ISO/PAS 8329

Description of mechanical connections
and joints in structural systems

ISO/PAS 8329 xMCF WG meeting
focus group on issues [#95](#) / [#104](#)
2026-09-09

Issue #106: Support complex rivet-nut fasteners

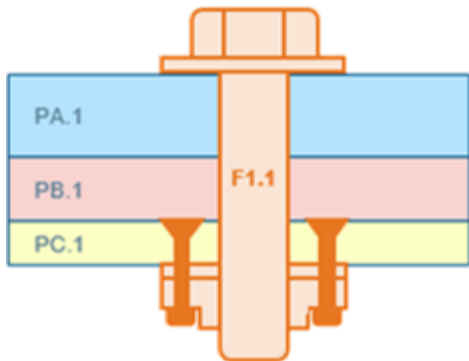
The task is to describe a design like this:

The discussion showed that this type of modelling is feasible. It can be described using the published standard.

GH outlines a solution and invites discussion:

1. The nut is riveted to part PC.1.
⇒ One `connection_group` between PC.1 & nut.
2. The bolt connects PA.1, PB.1, and PC.1.
The nut is modeled "`fixed_to`".

I created this slide
after our meeting.
Is it correct, so far?

GH will add a note to STEP's recommended practices and also post a comment on issue #106.

The issue will then be closed. // Done 2026-07-27.
